SCOLMORE

MinIGrid

Switches

APPROVAL SHEET

A103

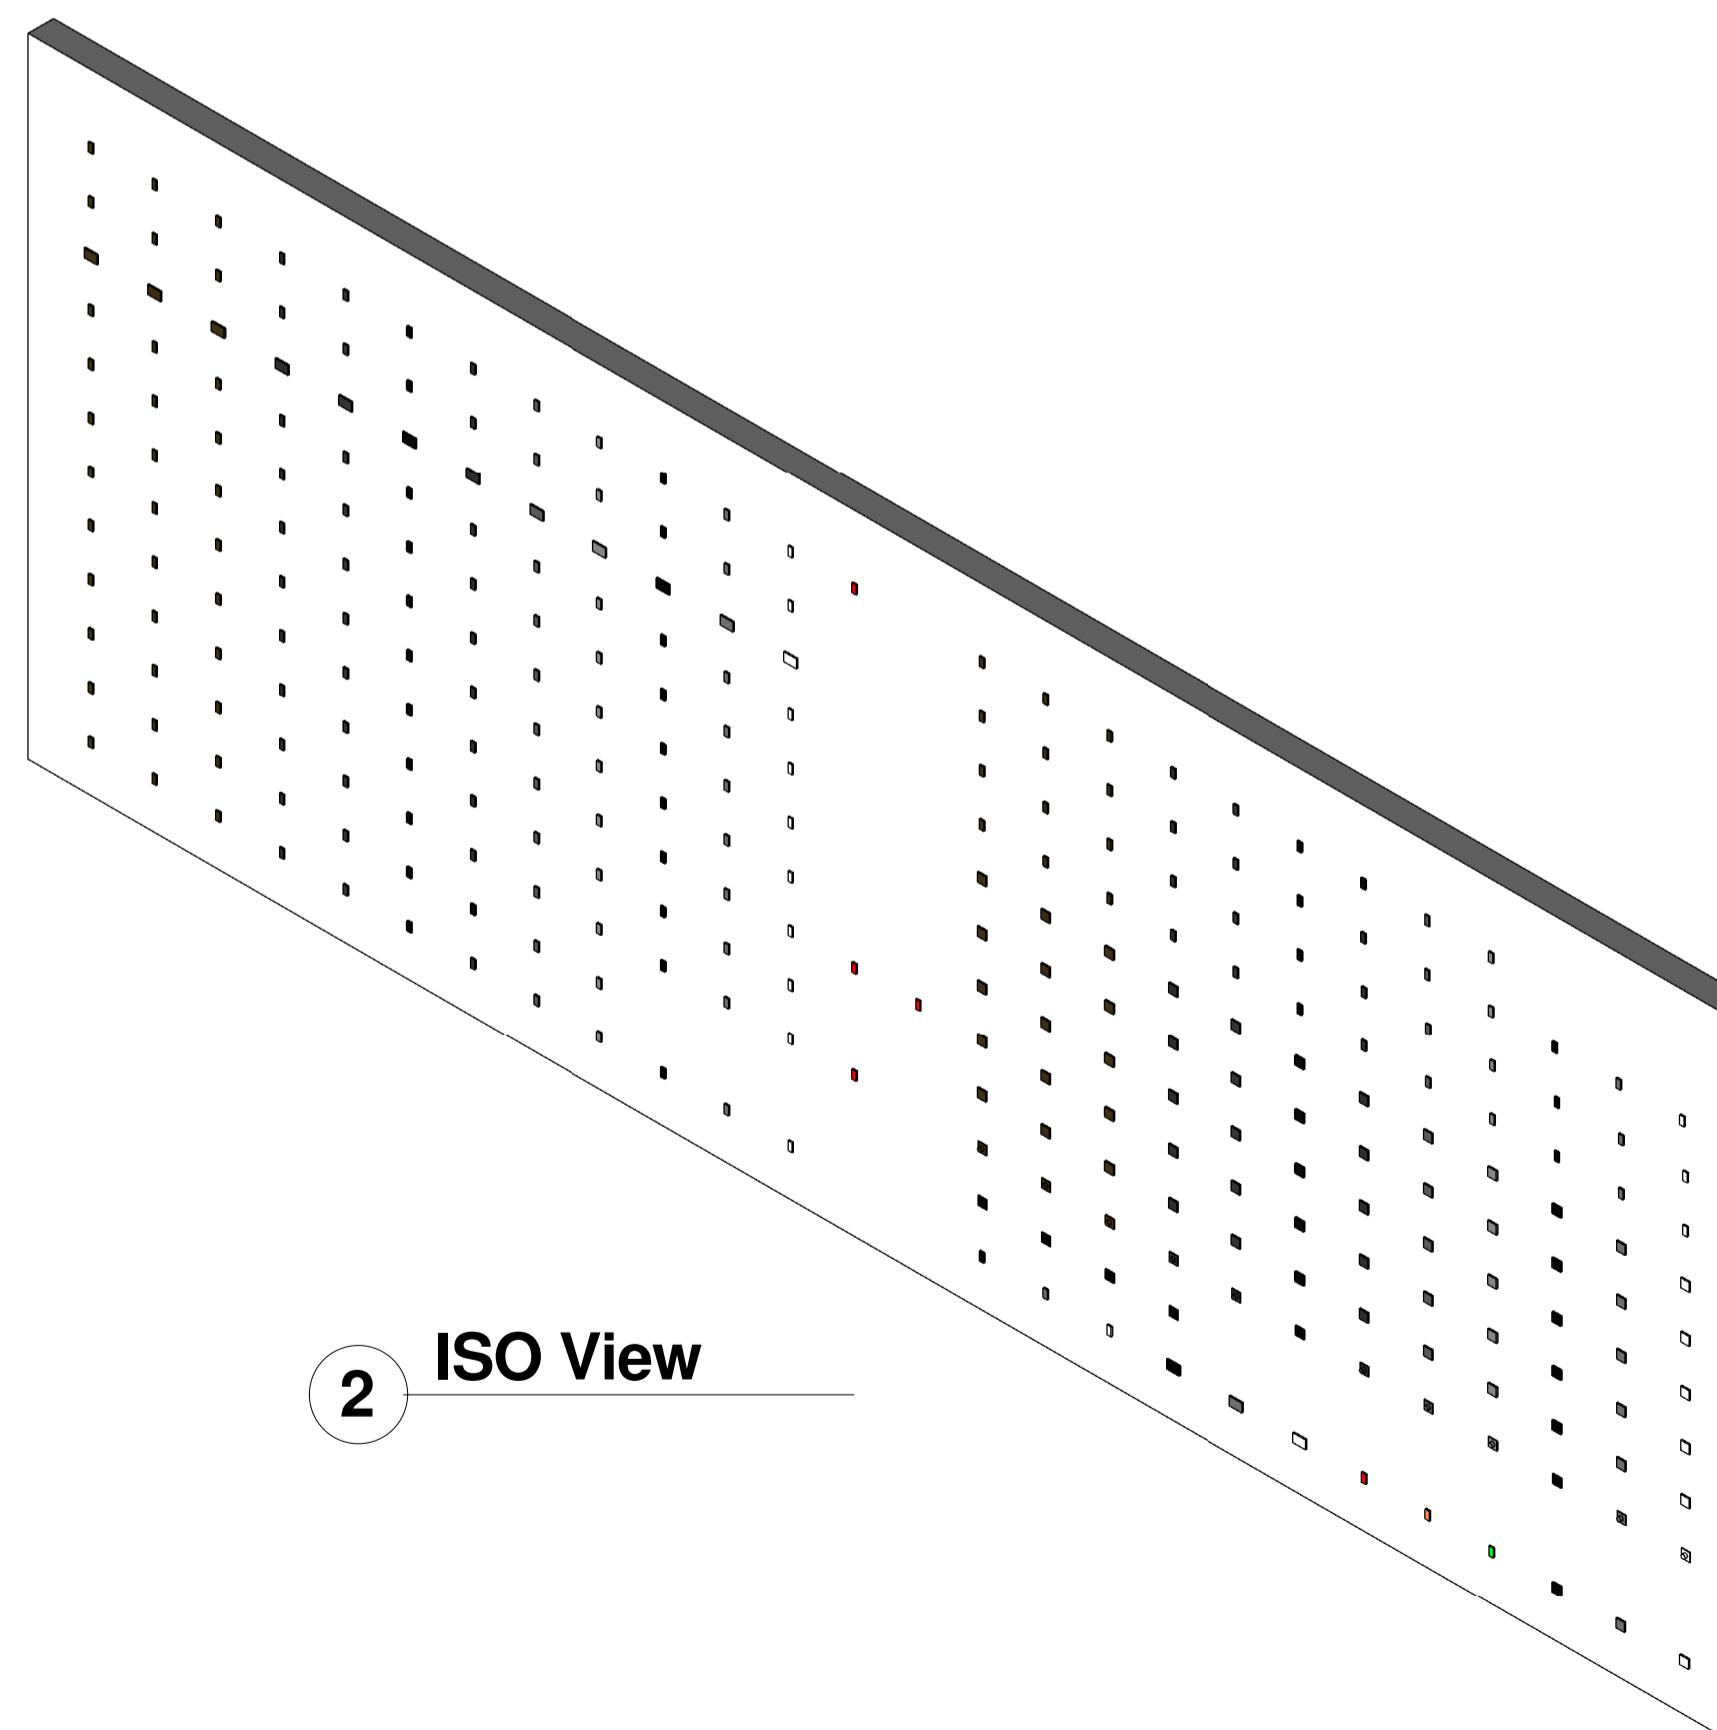
1. Mark Numbers 30, 31 & 38 Model numbers corrected.
2. Mark 105 Description updated to '10AX DP 13A Resistive Key Switch 'Test'.
3. Mark numbers 106 to 175 - Type comment updated.
4. Marks 264-266 Type comments updated.
5. Mark 265 Model Number corrected.
